PlanGrid Task Report - Sep 9, 2024

Prepared by Stephen Tassinaro

Sep 9, 2024

#466 [UNIT 999] - RTU Alarms Present

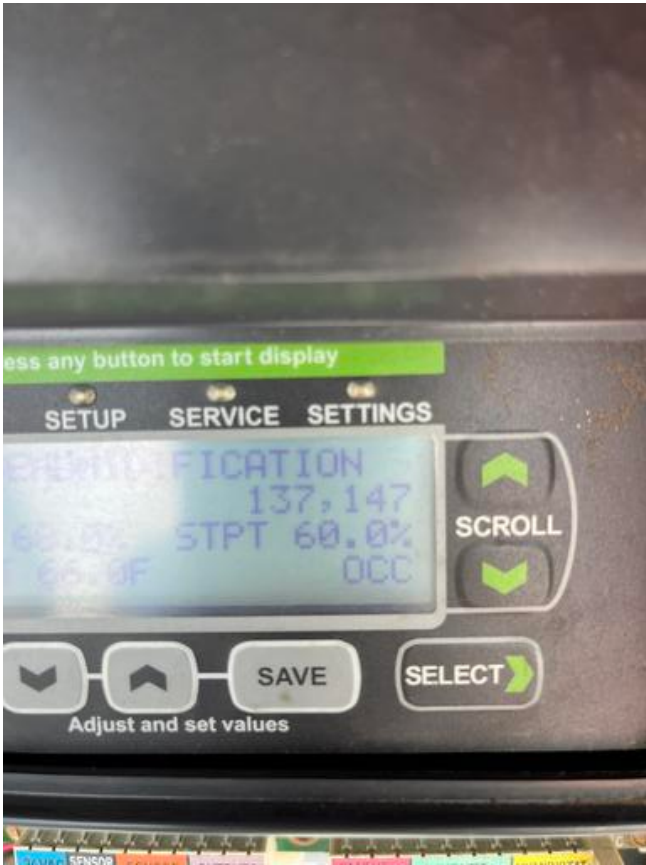
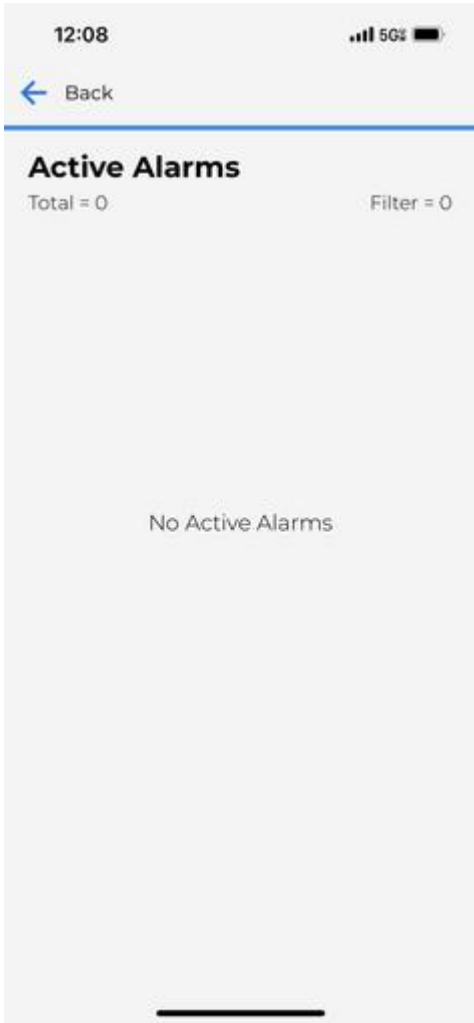
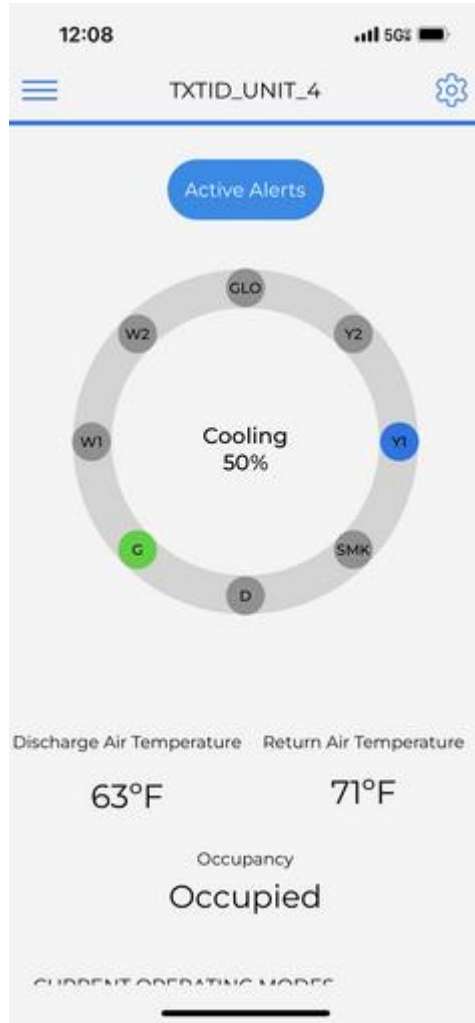
The following alarms were found on the RTUs:
RTU 3 - Alarm 147 & 137

RTU #3 alarming 137 & 147. Economizer functioning correctly and at NTi setpoint.

No active alarms on RTU's 1,3,4

#429 Return Grille 2-1 Not Located

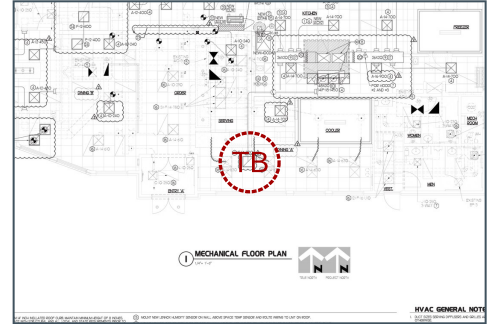
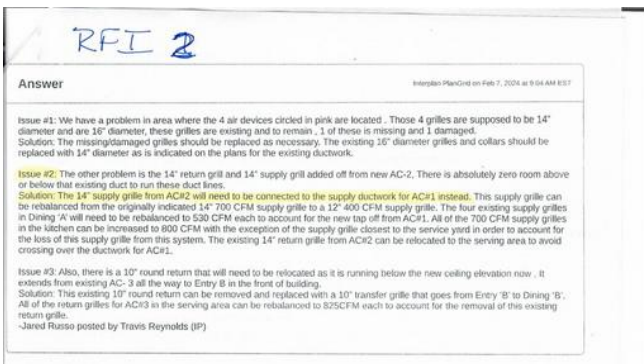
Description
Return Grille 2-1 could not be located in the space. Per M1.1 it should be located adjacent to diffusers 1-1 and 1-2 (side dining area).
*Reference NTi GRD Layout.

No change

NTi diffuser balance satisfies RFI #2 as-is. No changes required.

#425 [CNTL 999] [NEW] (MISC) Mini Split Wiring

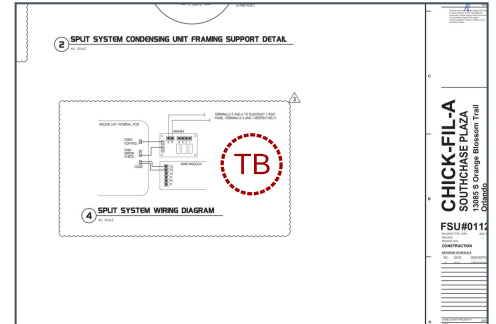
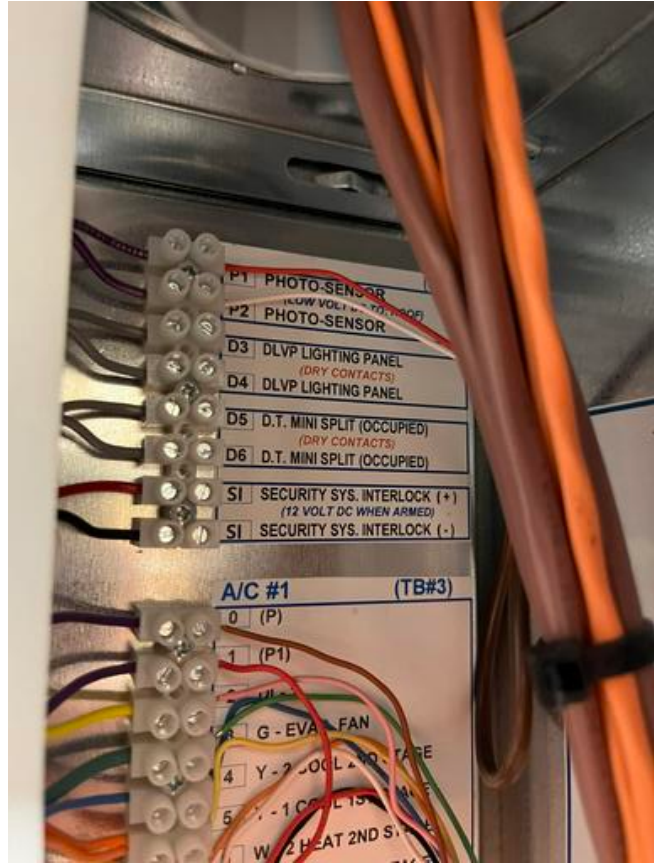
Description
Mini split control wires not landed in suncoast panel.

No wires landed 6/19

No wires landed 9/9

#412 [CNTL 508] [NEW] Controls labeling.

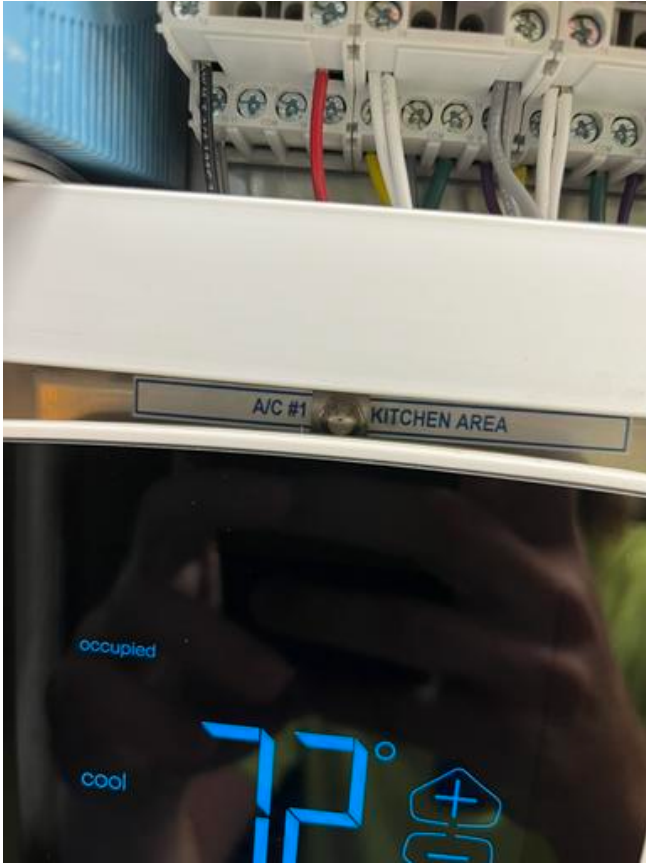
Label all sensors, humidistats, thermostats, smoke annunciators and remote space mounted OADs, MODs, VFD's for which piece of equipment they serve. Remote sensors labeled incorrectly (wrong units). Thermostats 1 and 2 labeled incorrectly (switch labels).

All sensors are now labeled but the label numbering does not match the mechanical plans. Per the mechanical plans: RTU 1 - Side Dining, RTU 2 - Kitchen, RTU 3 - Dining "B", RTU 4 - Dining "B" (where playroom previously existed).

Thermostat labeling not corrected. RTU 1 serves the side dining and RTU 2 serves the kitchen, per the mechanical plans.

See above comments. Sensors are labeled, but labeling does not match the mechanical plans.
